ADA Site Review and Comments

Project: **Chinsegut Hill Retreat**
22495 Chinsegut Hill Rd, Brooksville, FL 34601

Summary: **Accessible path slopes/surfaces, accessible parking space, ramps slope, emergency egress accessibility**

Figure 6: Proposed Accessible Parking Location

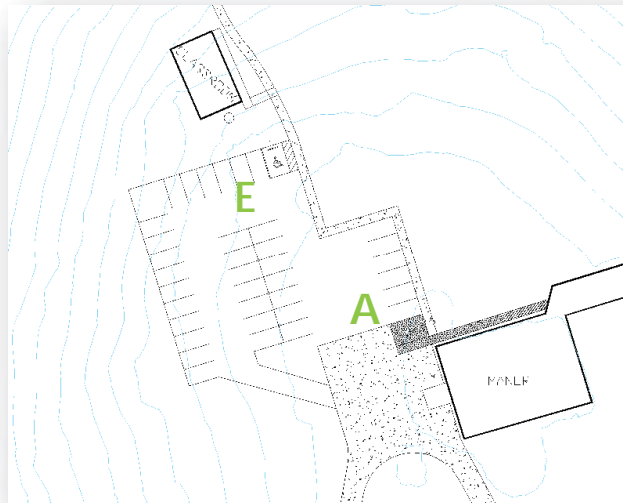
Only 1 of the 2 required accessible spaces are provided based on available parking spaces. While the parking spaces are not delineated in the grass parking area, it is understood these areas are routinely parked for events based on perimeter provided.

Possible Solution: Provide an additional ADA parking space in parking area 'E' near the entrance to the retreat area. Alternately, the space may be located next to the existing parking space 'A', or if vehicles are permitted or desired in the retreat area, near the accessible cabin 'K' or at the entry to Dining Hall 'Q'. If no other vehicles are permitted in the Retreat area during retreats, location E is the most compliant area.

Accessible parking spaces shall be paved (3000 psi concrete, 5" min. thickness is recommended on compacted soil) 12'-0" min. in width and 18'-0" in length designated with a 4" blue painted line on each side of the space with a 5'-0" wide aisle marked with 4" diagonal lines. Aisle and sidewalks shall be 4" thick concrete at a min. of 2500 psi. Spaces shall be marked with an accessible parking sign with violation notice meeting the state statues. (Figures 7 & 8)

Figure 10: Parking Space

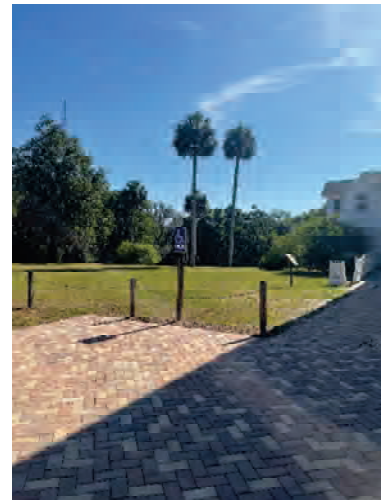
Spaces: 1
Parking Type: 90 degree
Stall Size: 12'-4" X 19'-11" (12' Width Req. - FAC502.2)

Hernando County Requires Accessible Parking to be striped
Cross Slope = <2% (<2% or <1:48 allowed - FAC 406.3)
Running Slope = 2% (<2% or <1:48 allowed - FAC 406.2)

Improper Height: 53" (<84" & >60" Abv Grade - FAC 502.6.1)
Improper Type: Missing Penalty and Statute # (International symbol of accessibility and the caption "PARKING BY DISABLED PERMIT ONLY." Such a sign, erected after October 1, 1996, must indicate the penalty for illegal use of the space and state statute #. Face of sign to be located 24" min. from face of curb.

Remount existing sign to taller pole so bottom of sign is placed between 60" and 84" above grade. Consider adding required parking striping to comply with Hernando County Standards. (Figure 11)

Figure 26: Accessible Restroom

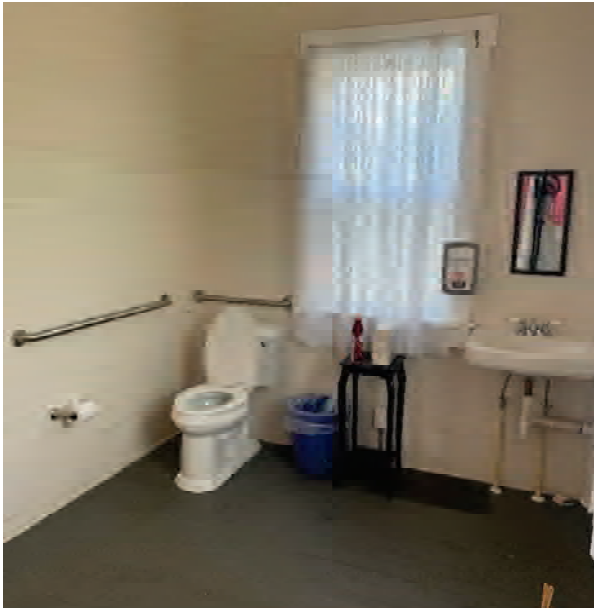
- C:** Accessible Restroom: An accessible restroom is located in the office/foyer space at the top of the accessible ramp at the Main House (C) (Figure 26)

- ✗** Water Closet Height: 17.5" (19" Required) (Figure 27)
- +** Side Clearance: 18" (18" required) (Figure 28)
 Flush Lever on Room Site: Yes
 Lavatory Depth: 21" (19" required) (Figure 31)
 Controls: Levers are Historic (Exempt)
 Height: 33" (32" – 34" Required) (Figure 33)
- ✗** Lavatory Side Clearance: 4" (6" required) (Figure 32)
 Scald Protection: Missing (Figure 34)
- +** Door Clearance: Push 23" (12" Required) Pull 18.5" (18" Required 24" Preferred)
 Door Signage: Sign at 54" AFF w./ Brail (Figures 35-36)
- ✗** Grab Bars: 24" Rear 48" Side (36" Rear and 48" Side) (Figures 29, 30)
 35" High (34" – 36" Allowed) (Figure 26)
 (Historic Exception Allowed for Window)

exempt from the ADA where such improvements are not physically possible or will alter the historic nature of the building. In this case, the restroom has been moderately altered and some improvements are possible. Grab bar and lavatory alterations are not possible without relocating a window and thus, NO CHANGES are possible.

The only change possible in this space is to **install scald protection on the piping under the sink.**

Figure 50: Threshold

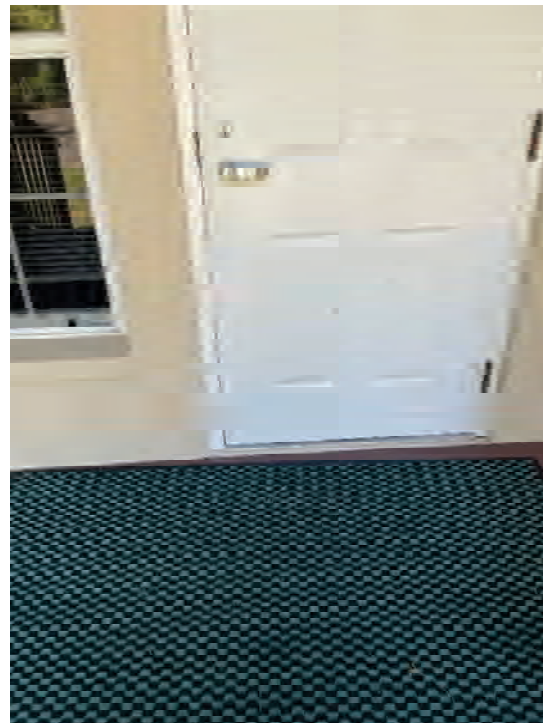
+	Width:	40.5" (Min. 36" Width Required) Building has an estimated occupant load of 6 negating the 44" egress requirement.
	Length:	12'-6" (Max. 30' allowed)
✗	Slopes:	<2% Cross Slope & 9.4% Running Slope (Max. <2% Cross Slope and <8% Running Slope allowed)
+	Landing:	60" x 60" <2% Slope (60" x 60" @ <2% Slope Allowed)
✗	Guardrail:	38.25" (Min. 42" Required)
	Picket Spacing:	4-5/8" (4" Max. allowed)
	Handrail Dia:	Non-Compliant Design (1.5" Dia. required FAC 505.6)
	Handrail Extension:	4" (12" min. Required FAC 505.10)
	Handrail Clear:	Non-Compliant Design (1.5" min. clearance required FAC 505.5)
+	Threshold:	.25" change in elevation (.5" allowed with a .5" bevel otherwise .25" maximum allowed FAC 303.2) (Figure 50)

Replace warped pressure treated deck boards at top landing (deck) and secure with stainless steel fasteners or Polyester Epoxy coated deck screws. Demolish and replace existing steps with Pressure treated steps set on concrete foundation or replace with concrete steps with 7" risers and 12" treads with 1" nosing on each step.

Figure 63: Accessible Path A-Q

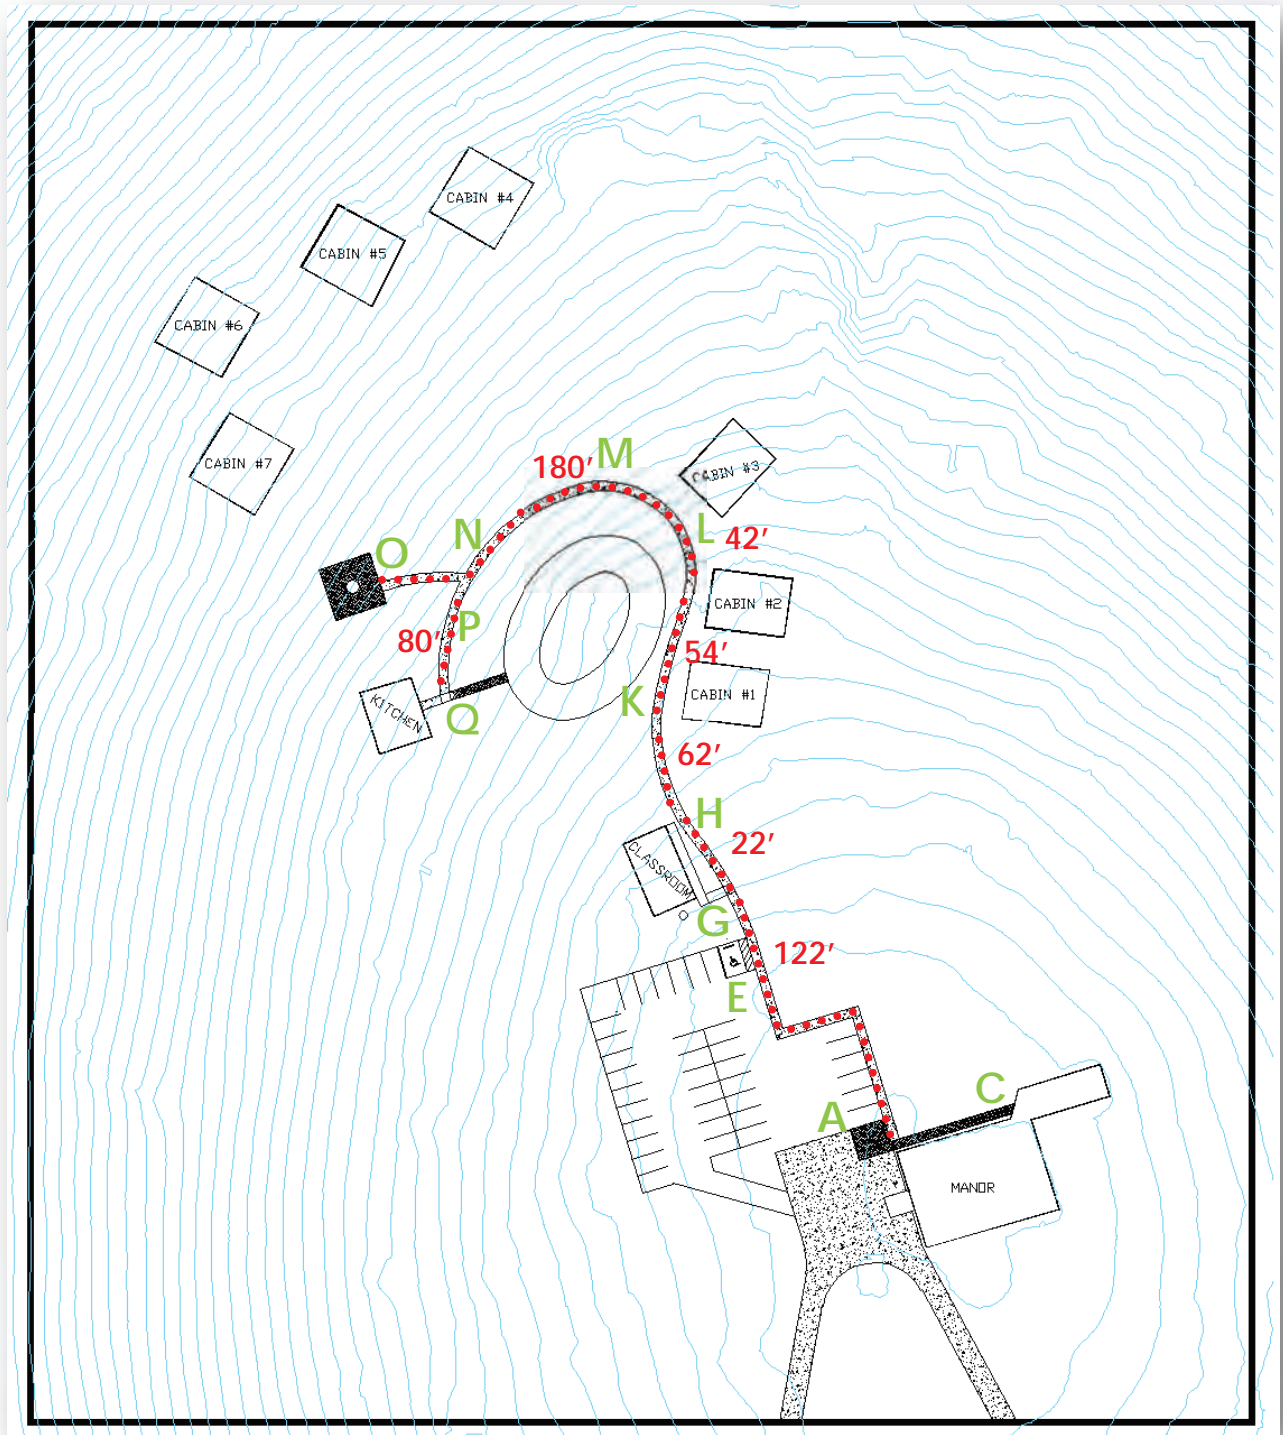
No Accessible Path exists connecting public spaces on the site to include the Manor House (B), Parking Area (A&E), Classroom Cottage 2 (K), Fire Pit (O) and Dining Hall (Q). Excluded from this requirement are cottages 4-7 which are not required to be on an accessible route as these are not accessible lodging. (*Figure 63*)

A-E: <2% Slope in the direction of travel
E-H: 3%-7% Slope in the direction of travel. (Requires arc in sidewalk path to reduce slope to <5%).
H-K: 4% Slope in the direction of travel
L-M-N: 4% Slope in the direction of travel
N-P-Q: 5% Slope in the direction of travel. (Requires arc in sidewalk path to reduce slope to <5%).

An accessible path is required to have minimum lighting at the exterior of 0.2 Foot Candle (2.15 Lux) at the walking surface. (FBC 1008.2.1 Exception 2). Steps, landings and the sides of ramps shall be permitted to be marked with self-luminous materials in accordance with Sections 1025.2.1, 1025.2.2 and 1025.2.4 by systems listed in accordance with UL 1994. The exterior accessible path, building ramps, porches and landings were not observed in low natural lighting conditions with the exterior lighting fixtures on. It is recommended that the lighting levels be measured at the walking surfaces of the accessible path. *(Figure 63)*

Install a 5'-0" wide concrete sidewalk (min. 4" thick @ 2500 psi with control joints in 5'-0" increments) from the Manor House to Dining Hall (connecting points A, D, E, G, H, K, O and Q). Potential path indicated in (*Figures 56-57*). Path shall be no greater than 5% in slope in the direction of travel with a maximum 2% cross slope which is possible in

the general path shown in Figure 6. The sidewalk can be curved to fit with the dynamics of the land, reduce slope to less than 5%. prevent abrupt changes in direction requiring landings and avoid trees and tree roots. (Figures 57-61, 63)

If lighting levels at the exterior accessible path measure less than 0.2 Foot Candle (2.15 Lux), install full-cut-off lighting fixtures intermittently to provide minimum lighting levels. Note, fixtures can be specified which are motion activated, solar powered with batteries which are ideal for commercial applications and can be mounted to poles. An electrical engineer is recommended for this phase of work.
